DATE: 11/28/23

FROM: CITY MANAGER'S OFFICE

SUBJECT: COUNCIL Q&A FOR NOVEMBER 28, 2023 CITY COUNCIL REGULAR MEETING

CONCEPTUAL PLAN

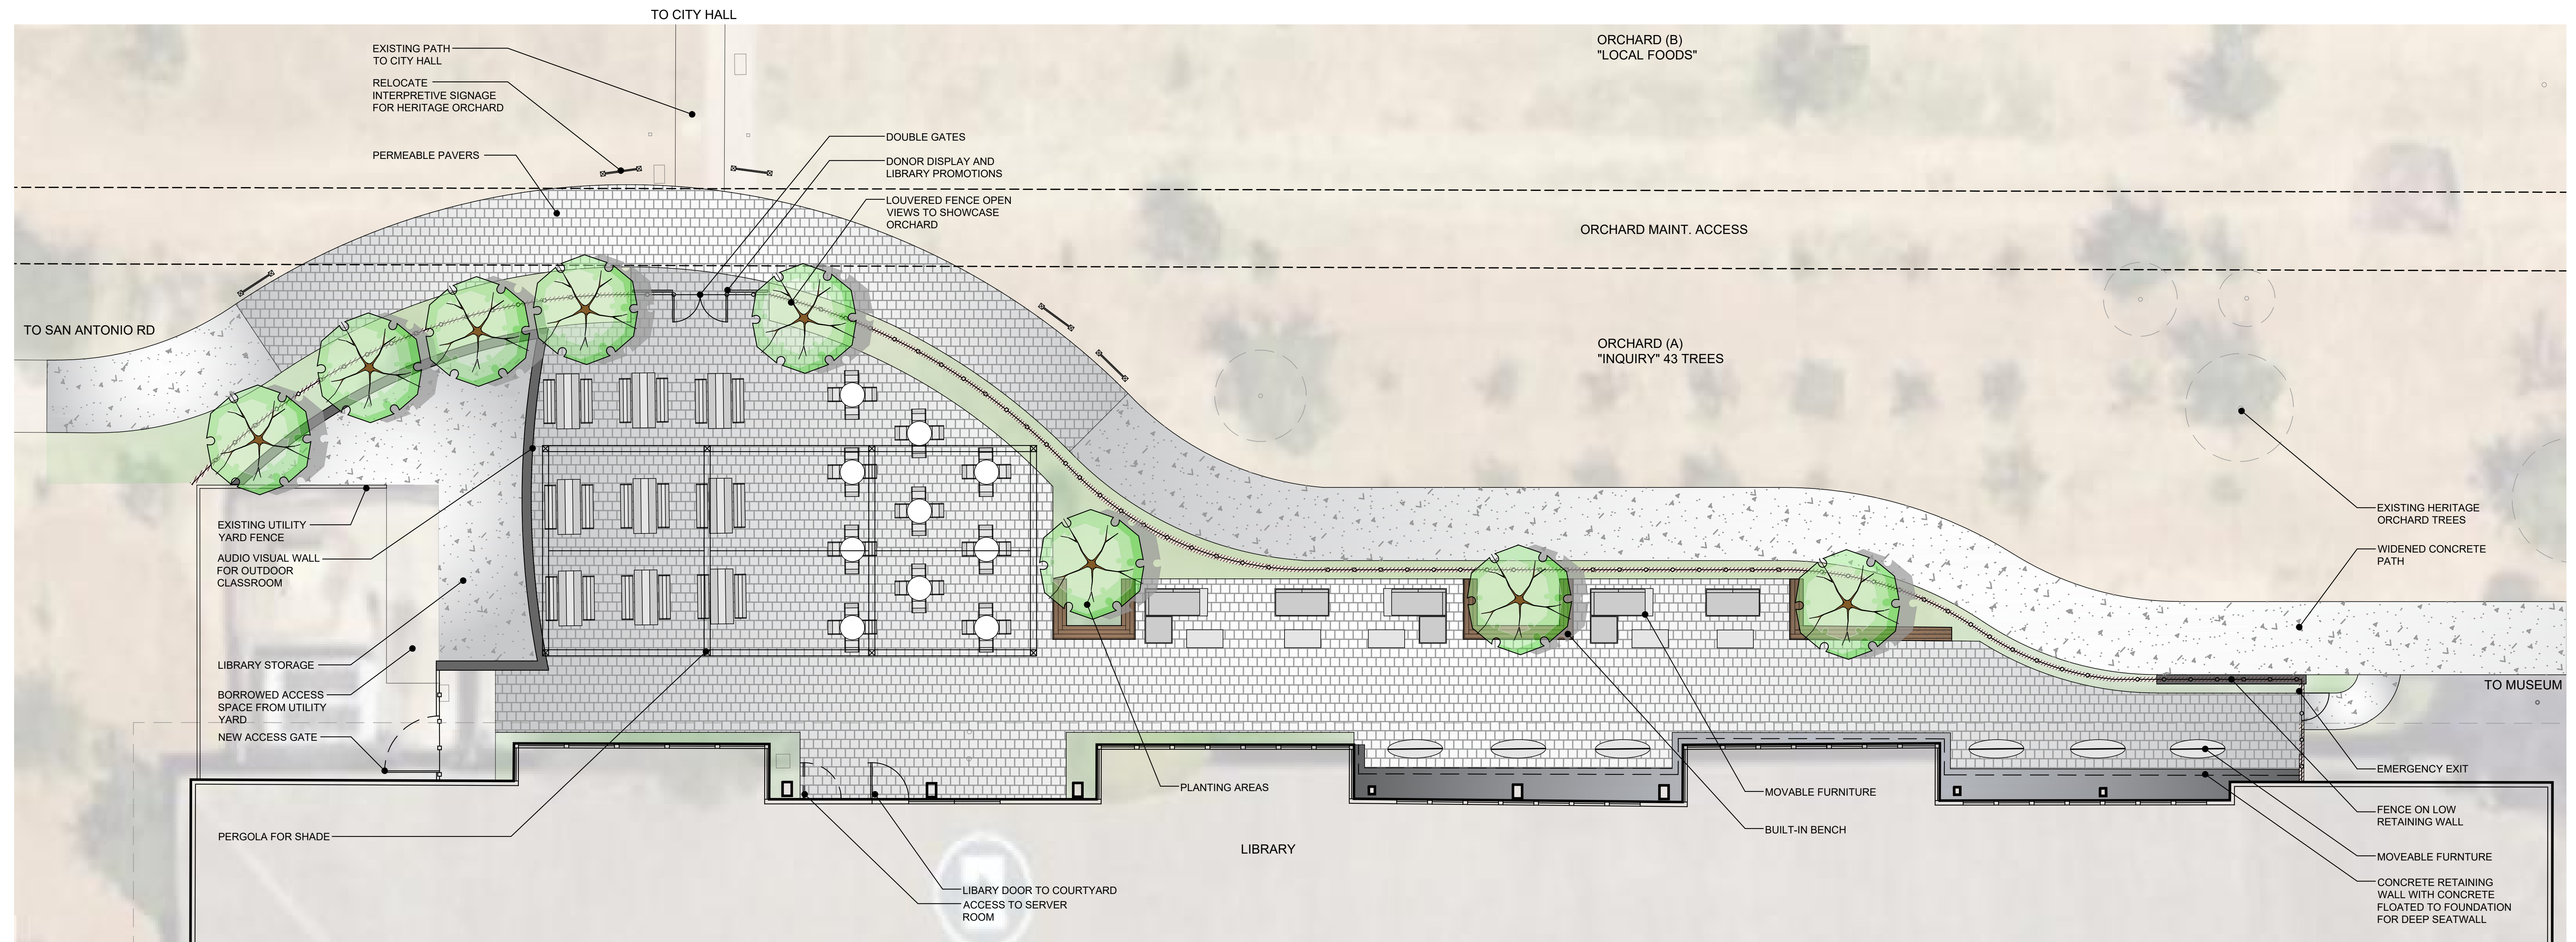
- Can you clarify the type of wall and the impact of the “WALLED DESIGN” of the wall around the Library Patio project, not only shade planes and impact on orchard growing conditions and surveyed boundaries?

- How will the wall impact the views of the seats with views and the large plate glass windows that was designed to integrate the buildings and the lands in the original civic center master plan.

Answer: This can be discussed and addressed by the Design Professional responsible for the proposed design.

Answer: The proposed fence material is not solid and allows onlookers to view both ways, from inside to outside and outside to inside. The fence proposed only creates a barrier for

safety when outdoor programming of the library is underway.
